# UNITED STATES PATENT AND TRADEMARK OFFICE

APPLICATION NO.	FILING DATE	FIRST NAMED INVENTOR	ATTORNEY DOCKET NO.	CONFIRMATION NO.
10/735,440	12/12/2003	Fabian Kollmann	3201-366 (D4700-00380)	2028
7590		01/31/2008		
STEPHAN P. GRIBOK DUANE MORRIS LLP ONE LIBERTY PLACE PHILADELPHIA, PA 19103			EXAMINER PHILLIPS, CHARLES E	
			ART UNIT 3751	PAPER NUMBER
			MAIL DATE 01/31/2008	DELIVERY MODE PAPER

<b>Office Action Summary</b>	Application No.	Applicant(s)	
	10/735,440	KOLLMANN ET AL.	
	Examiner	Art Unit	
	Charles E. Phillips	3751

SN 10/735,440  
Substitute Drawing

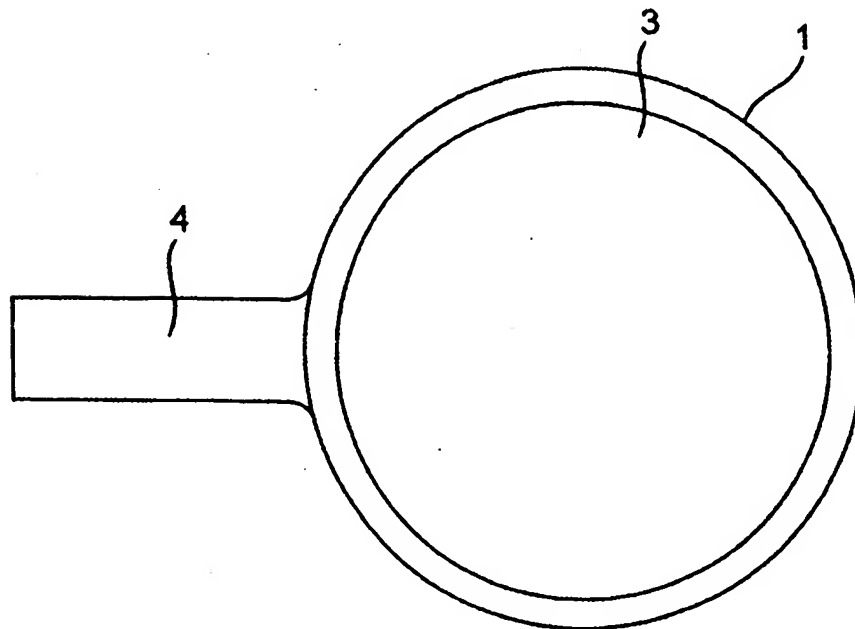
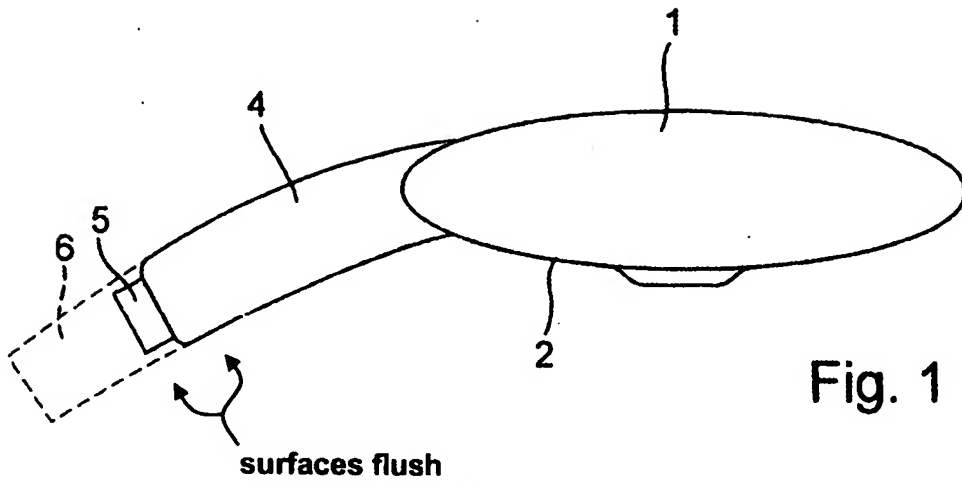
The proposed drawing correction filed on 9/28/07 is disapproved as the depiction of the union nut is inconsistent with that of the original drawings in that the double lines at the hose end are lacking, the fitting is of a different shape and the terminal end of the handle is rounded.

not approved  
11/9/07 CEP
